November 24, 2021

Subject: Laurel Elementary School HVAC Replacement
San Mateo - Foster City School District
Aedis Project No. 2021005.03
DSA Application #01-119551

ADDENDUM NO. 1

1 SITE ROOF PLAN
SCALE: 1/16" = 1'-0"

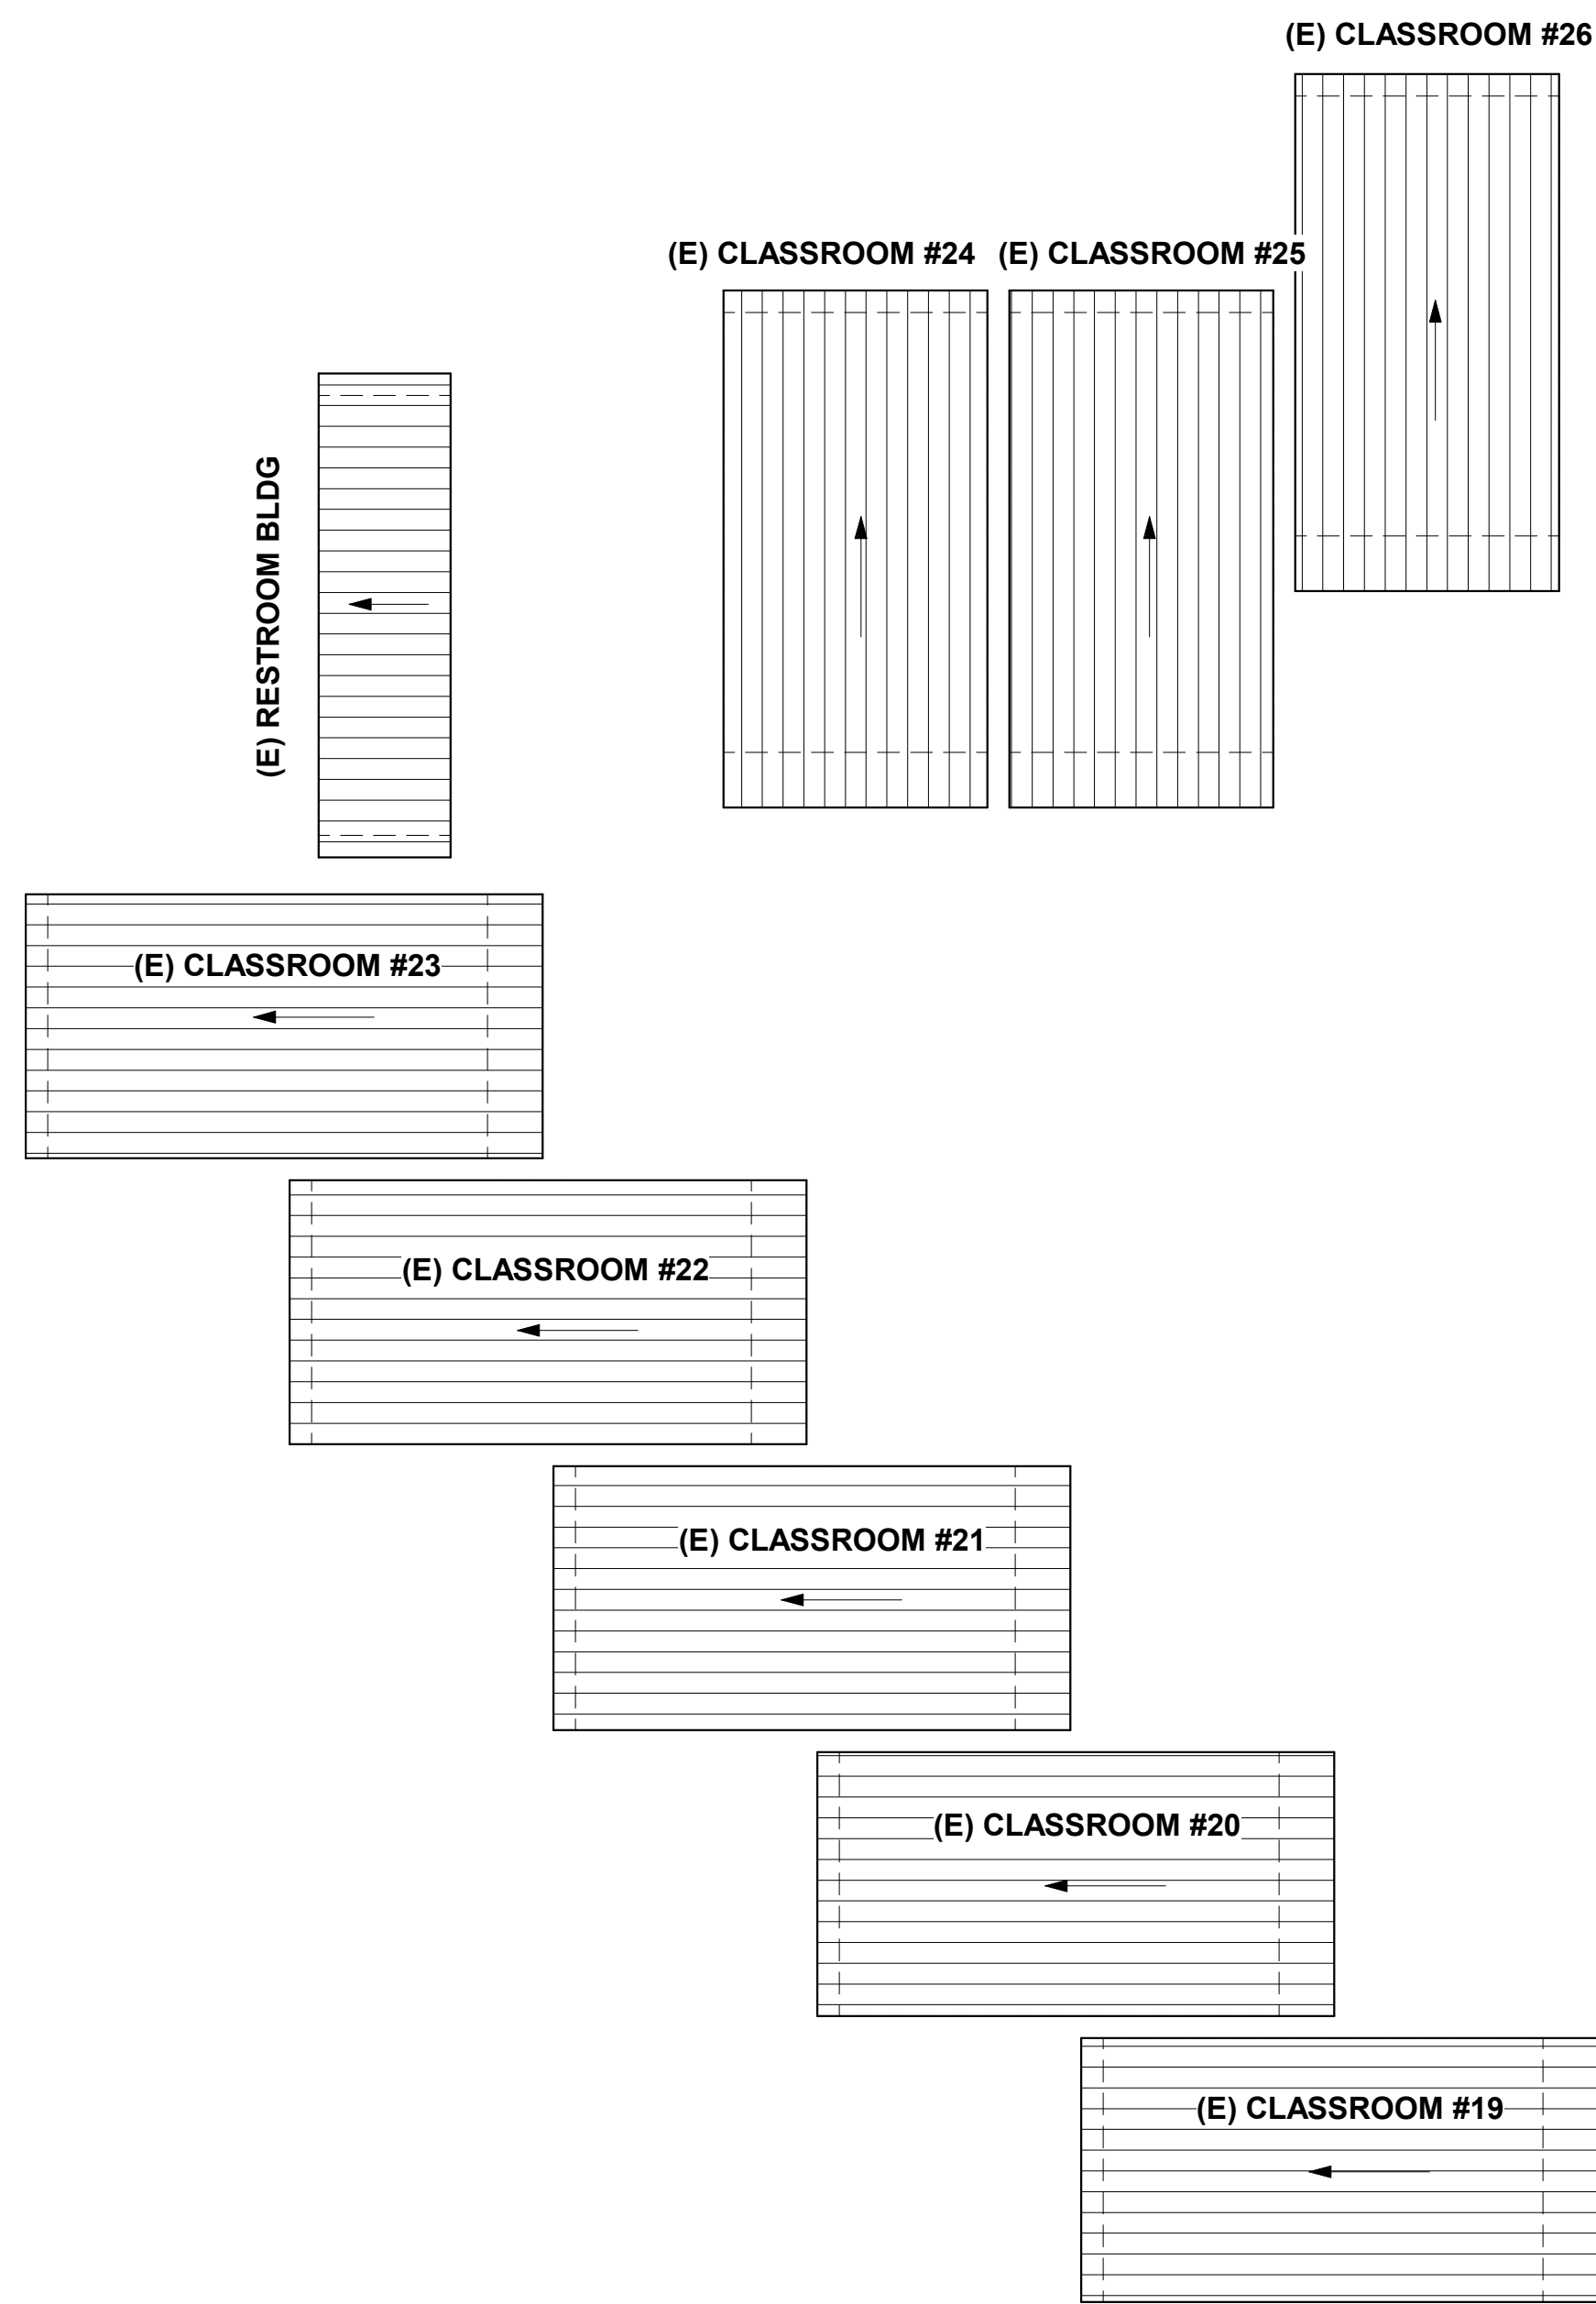
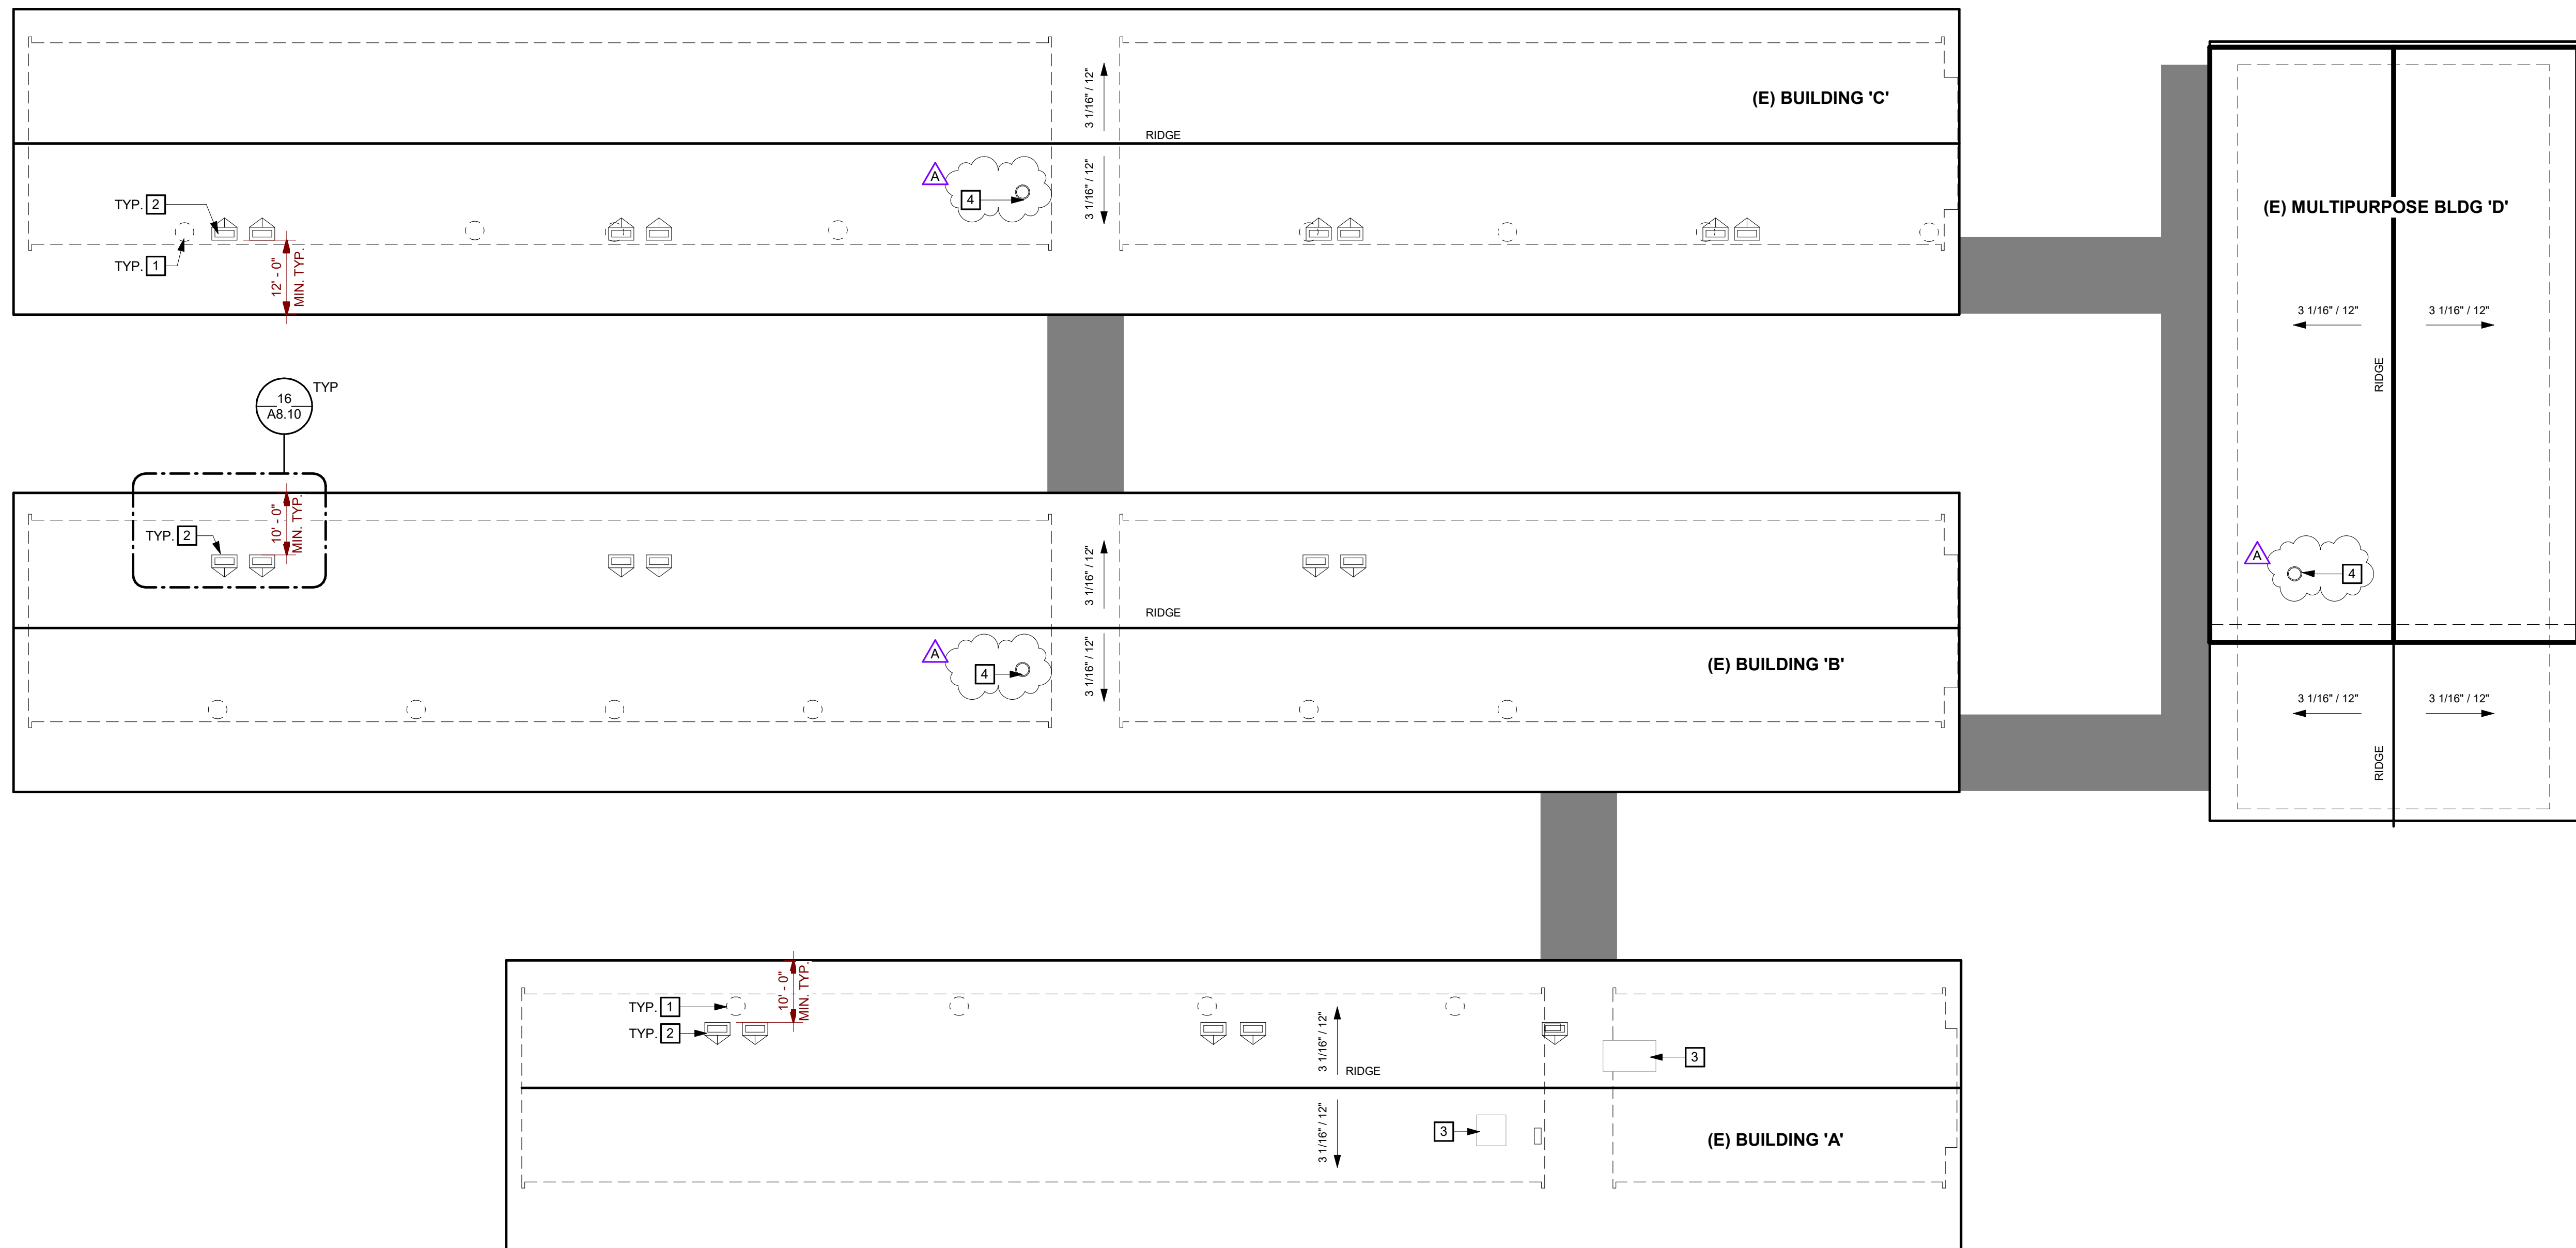
Add: Exhaust fans per AD1-A5.01
Add: General Note #C per AD1-A5.01
Revise: Site Roof Plan Keynote #2 per AD1-A5.01
Add: Site Roof Plan Keynote #4 per AD1-A5.01

WALL TYPE - MECHANICAL ENCLOSURE

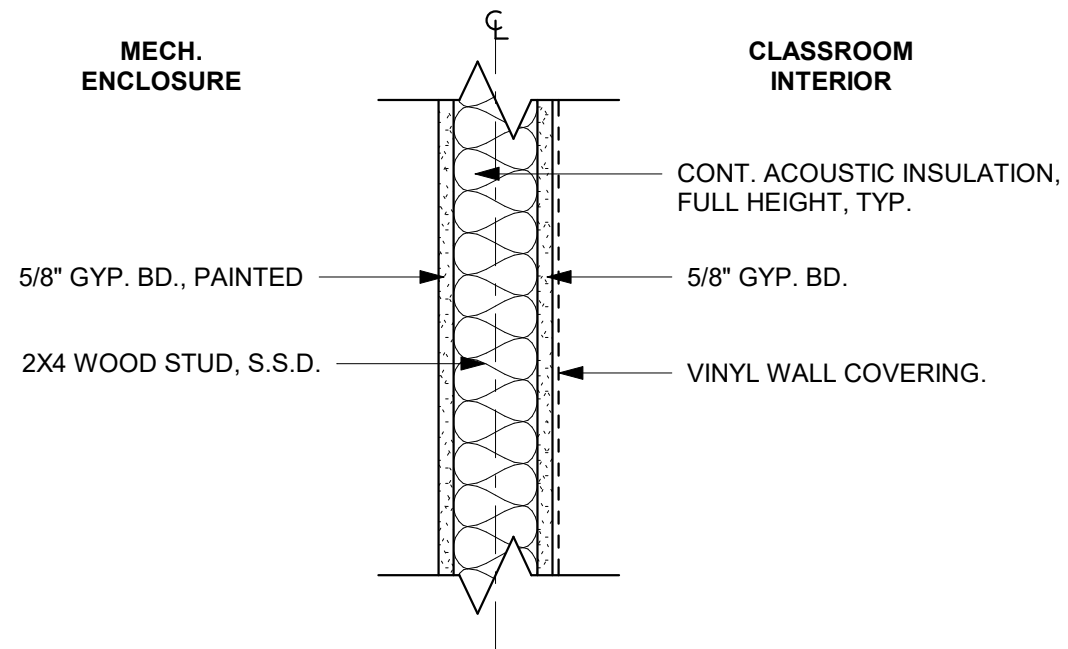
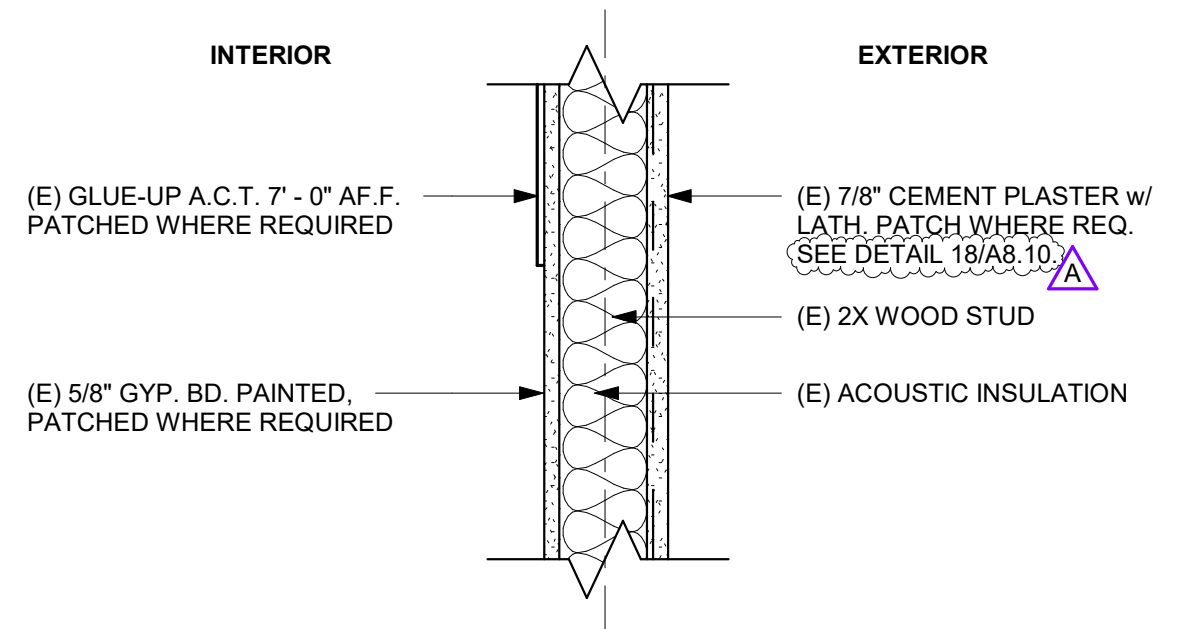
Revise: Detail 9 per AD1-A8.10

AD1-A9.10A

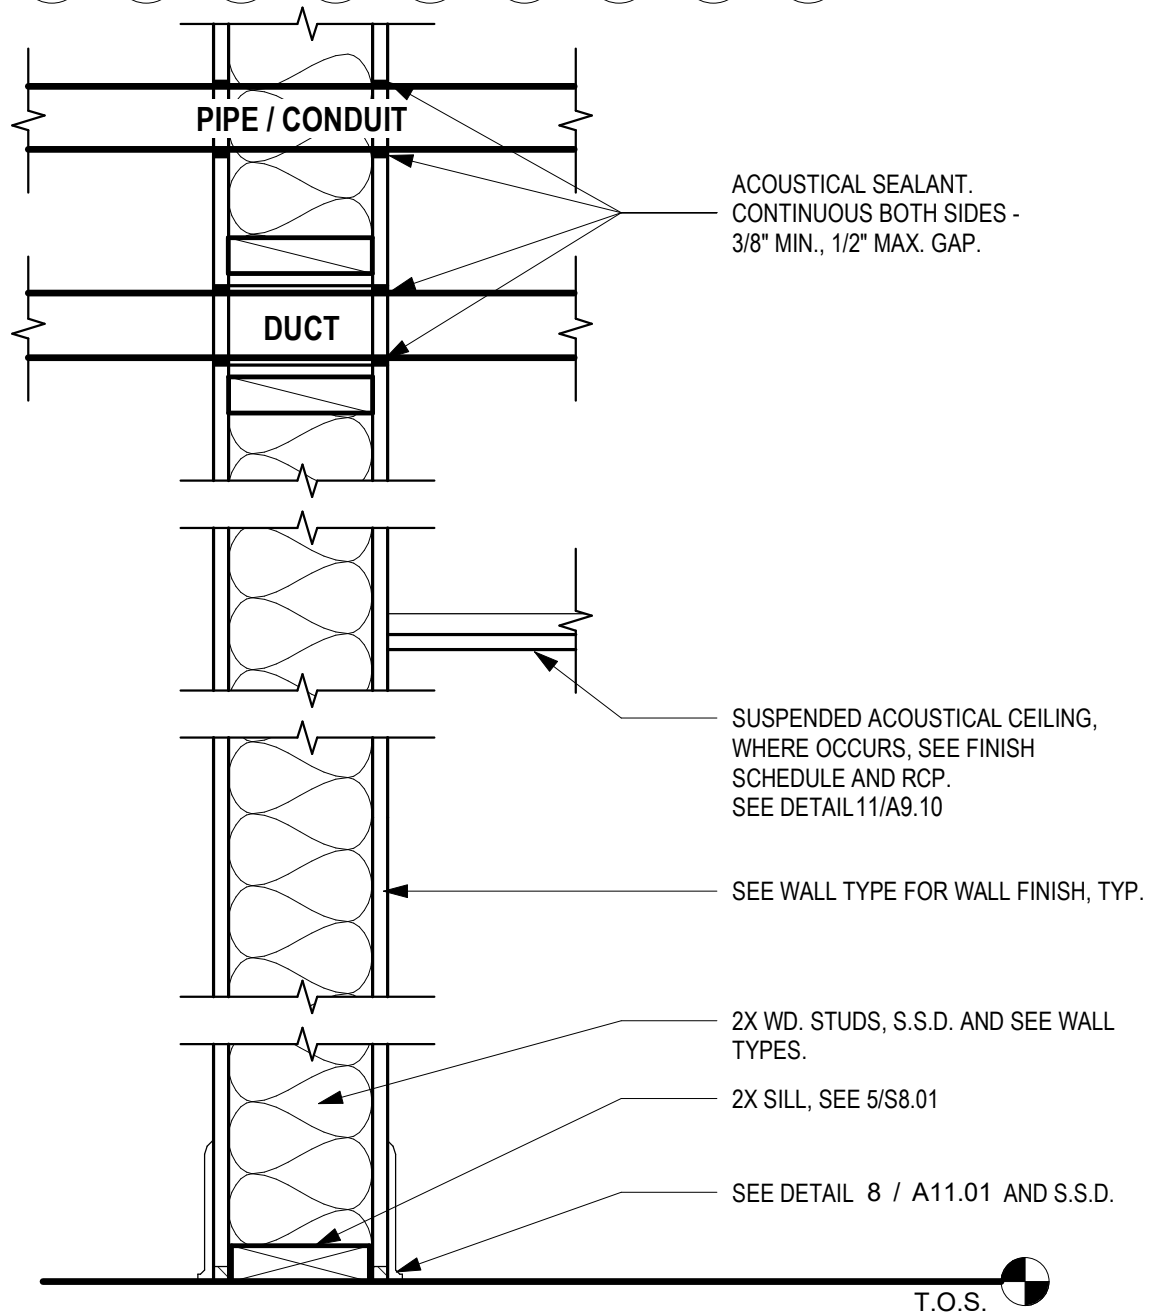
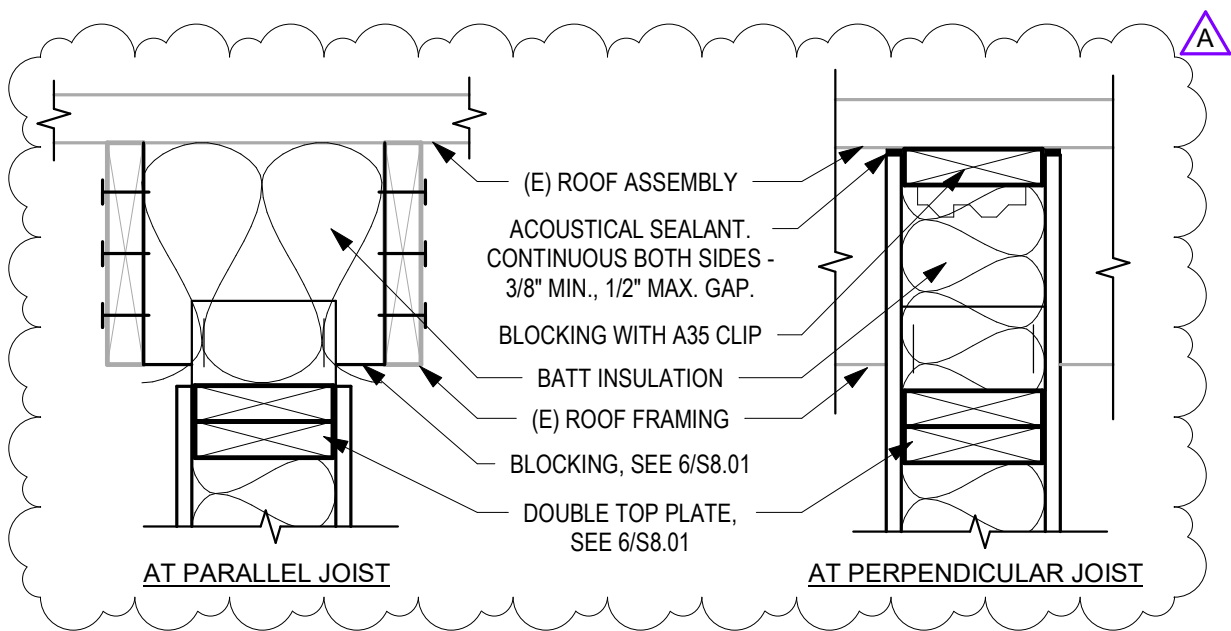
Revise: Details 1 & 4 per AD1-A9.10A
Revise: Detail 6 per AD1-A9.10A

DOOR TYPES
SCALE: 1/4" = 1'-0"

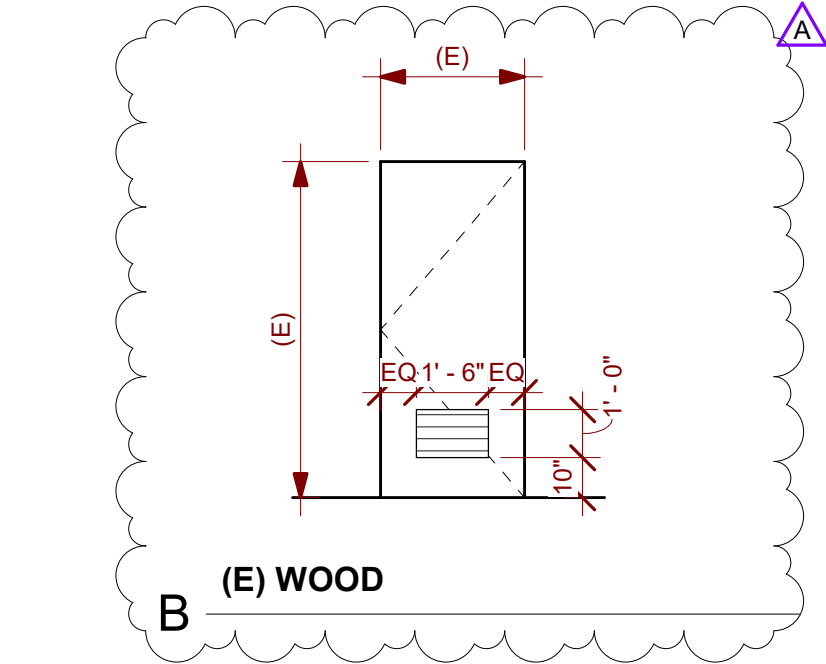
Add: Doors 7ab, 15ab & 41ab to Door Schedule per AD1-11.01
Add: Door Schedule Comments per AD1-11.01
Add: Door Type B per AD1-11.01
